CITY OF ANN ARBOR, MICHIGAN

GRANGER STREET PARKING PREFERENCE

Granger Avenue Street Parking Preference Survey Card Data

Locations of proposed on-street parking

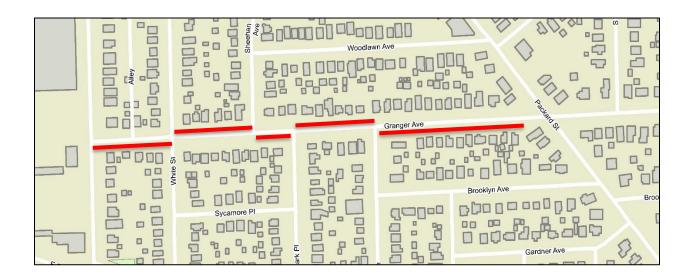
- 12. Our car has already been hit while parked on Granger at the end of a row of cars. Asking cars to weave back and forth along Granger would only cause more chaos. We suggest adding a cross walk at, say, Park ad Granger with signage, as on State St. were recently added. These have greatly improved ped. experience on State.

- 13. Staggered parking would only cause more problems and interfere with trash pickups etc. There's plenty parking already.
- 14. Speeding is a concern but staggered parking is not the answer. Speed bumps or stop signs would be more effective.

- 15. I do not agree with staggered parking as a solution. I think we will have more accidents by switching back and forth.
- 16. Granger St. from State to Ferdon speeding occurs the entire street length. Bad, wrong, survey only one conclusion choice effort. City engineer decided this one effort. The letter received from the Traffic Engineer, Cynthia Redinger is composed and worded with many contradictions, as is the postcard survey. Also, not carefully thought out. Tax paying resident owners on Granger Ave

Staggered parking will not address this situation. The enclosed proposal allows south side parking to the east side of the Granger-Golden intersection, obscuring the view in that direction.
